Product Change Notice (PCN)

PCN Number: PCN-0454694R-03

Product(s) Affected: *UP2-AH-1-TH & UP2-AH-4-TH*

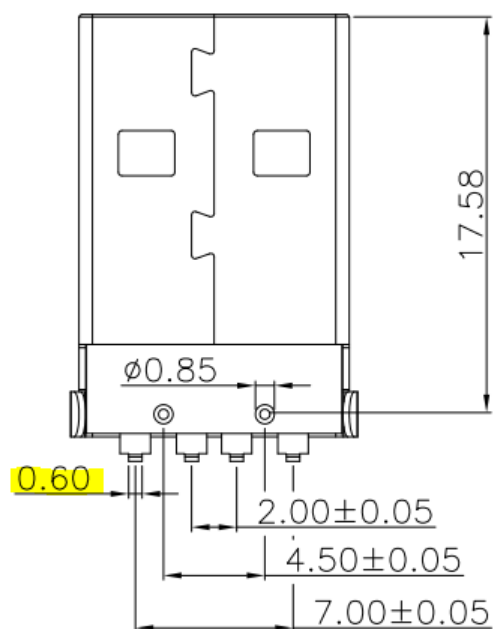
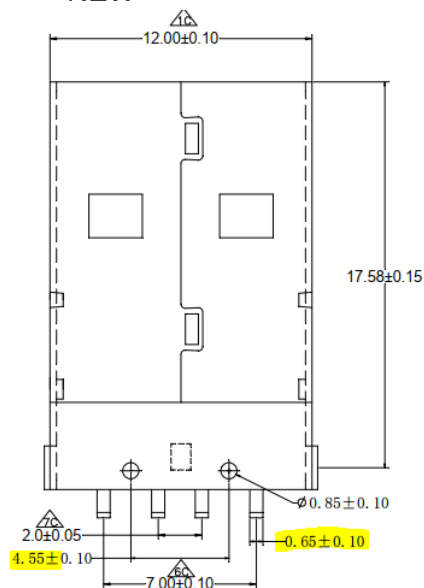
Reason(s) for Change: *Manufacturing process improvements. Tooling upgrade*

Description of Change: *Shielding lock orientation and solder pin angle*
